# **Amendment Report**

Licence Number L8454/2010/2

**Premises** Christmas Creek Mine Site

Date of Amendment 07/08/2020

Figure 1 - New proposed L3 emission point to land

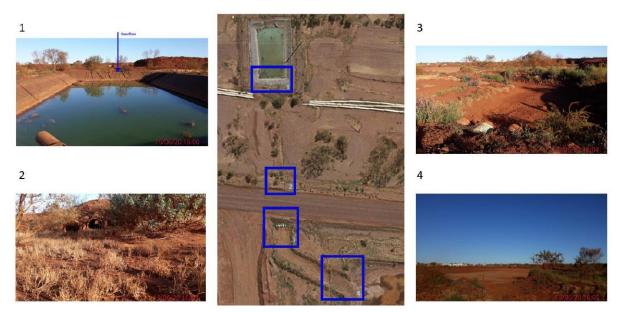
A new emissions to land discharge point is proposed (L3), for the discharge of oily water from the water separator (Figure 1). The discharge point is a gravity fed overflow from the pond through a low point in the southern embankment wall. Rock armouring is present at the overflow point to prevent erosion of the embankment wall. The water is then directed into a diversion channel that flows into the TLO Settlement Pond. The 200 mm freeboard requirement for the Power Station Pond is to be removed.

The Applicant will conduct quarterly monitoring for TRH from L3 emission point to land.
